**STAFF RECOMMENDATION**  
**4909 Elkins Avenue**  
**January 20, 2021**

**Application:** New Construction—Infill  
**District:** Park and Elkins Neighborhood Conservation Zoning Overlay  
**Council District:** 24  
**Base Zoning:** RS7.5  
**Map and Parcel Number:** 091150278.00  
**Applicant:** Lynn Taylor, TaylorMade Designs  
**Project Lead:** Jenny Warren, jenny.warren@nashville.gov

<p><b>Description of Project:</b> Application is to construct one and one-half story infill.</p> <p><b>Recommendation Summary:</b> Staff recommends approval with the following conditions:</p> <ol style="list-style-type: none"> <li>1. The finished floor height shall be consistent with the finished floor heights of the adjacent historic houses, to be verified by MHZC staff in the field;</li> <li>2. The front setback should be consistent with the buildings to either side, to be verified by MHZC staff in the field;</li> <li>3. Staff approve the final details, dimensions and materials of the roof color, windows, doors, stone, deck railing and porch post material prior to purchase and installation; and,</li> <li>4. The majority of the windows on the right elevation shall be twice as tall as they are wi

Figure 2. Proposed front elevation

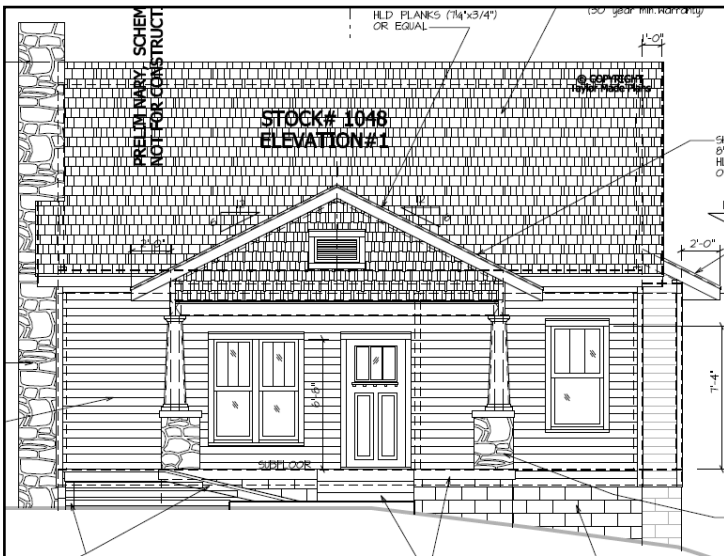
**Height & Scale:** The 4900 block of Elkins Avenue includes a mix of one, one and a half, and two-story historic homes. (Figures 3 & 4) The heights of historic houses on the immediate block face range from about seventeen feet to thirty-five feet (17'-35') tall. The proposed infill falls well within this range with an average height from grade at about twenty-two feet, six inches (22'6"). Houses on similarly sized lots range from

The project meets Section II.B.1.a. and b.

twenty-eight feet to forty feet (28'-40') wide. The proposed house again fits well within this range at thirty feet (30') wide, with a small two foot (2') wide bay on the right side.

The proposed depth is about sixty-eight feet (68'). The proposed house is very similar in massing to the historic house which will be demolished. The infill is modestly scaled and is appropriate to this historic context.

Figure 3. Right-side façade.

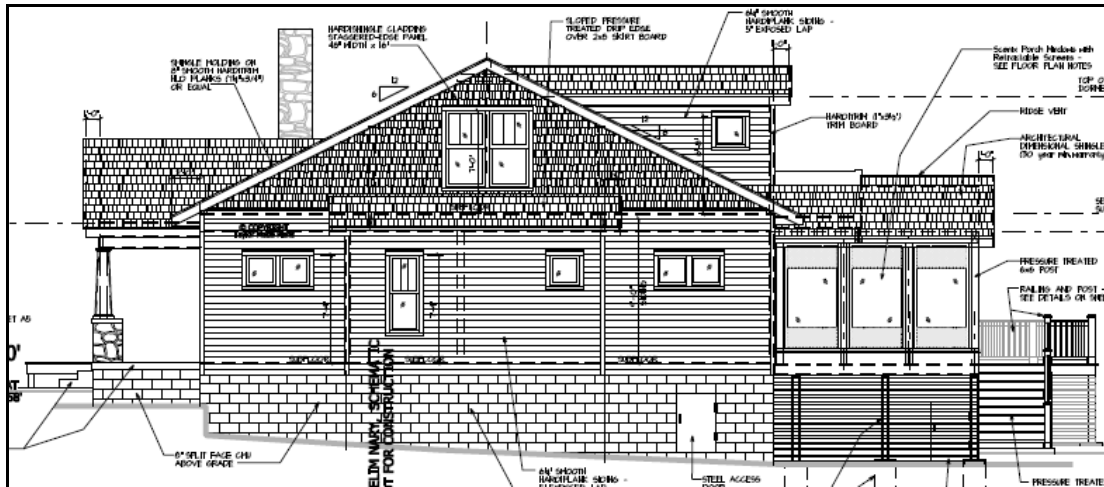
Proportion and Rhythm of Openings: Most of the windows on the infill are vertically oriented and appear to be approximately twice as tall as they are wide. There are smaller

squared windows on the sides of the dormer, which staff finds to be appropriate in this location. The right side elevation contains mostly square windows. (Figure 3) Staff recommends that the majority of these windows be lengthened to be twice as tall as they are wide. A few could remain as accent windows, but the majority of the windows should be vertically oriented.

With the condition that the majority of the windows on the right elevation are vertically oriented, staff finds the project’s proportion and rhythm of openings can meet Section II.B.1.g.

1. The finished floor height shall be consistent with the finished floor heights of the adjacent historic houses, to be verified by MHZC staff in the field;
2. The front setback should be consistent with the buildings to either side, to be verified by MHZC staff in the field;
3. Staff approve the final details, dimensions and materials of the roof color, windows, doors, stone, deck railing, porch post material prior to purchase and installation; and
4. The majority of the windows on the right elevation shall be twice as tall as they are wide.

SITE PLAN

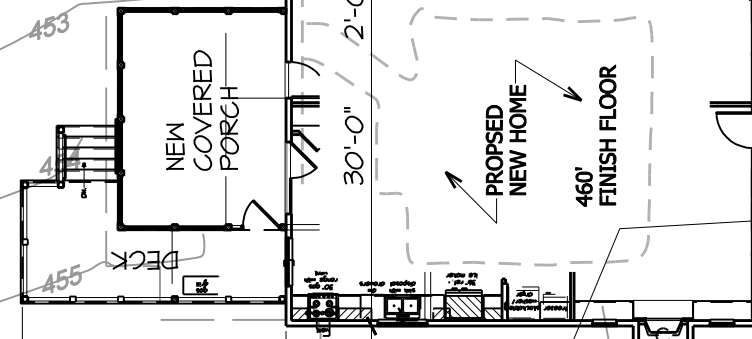
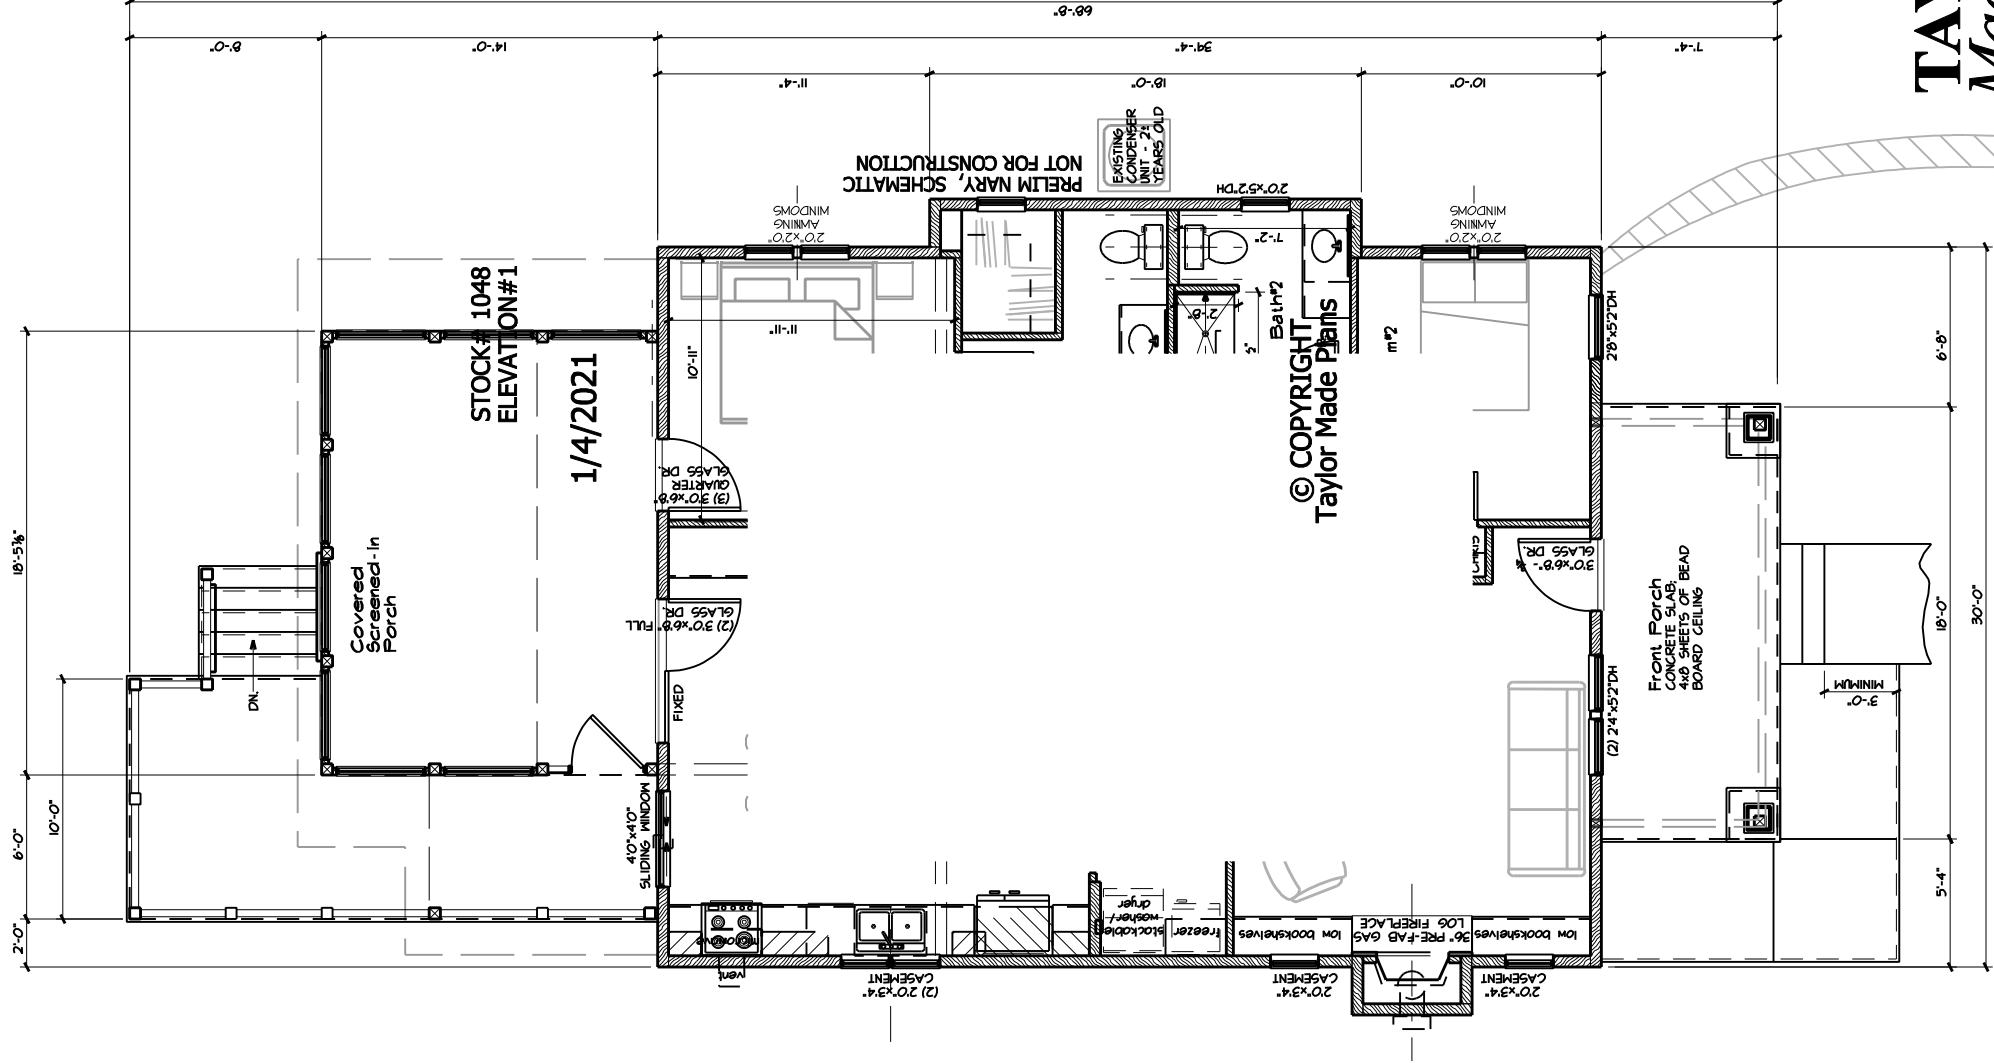
**Setback & Rhythm of Spacing:** The front setback is approximately thirty-one feet (31') and matches the setback of the historic house to be demolished. It lines up with the historic house on either side. The infill is located eight feet (8') from both side property lines. A small bay on the right side sits six feet (6') from the property line. The rear of the house is more than ninety feet (90') from the rear property line. The project meets all base zoning setbacks and the setback and rhythm of spacing are appropriate for the historic context.

The project meets Section II.B.1.c.
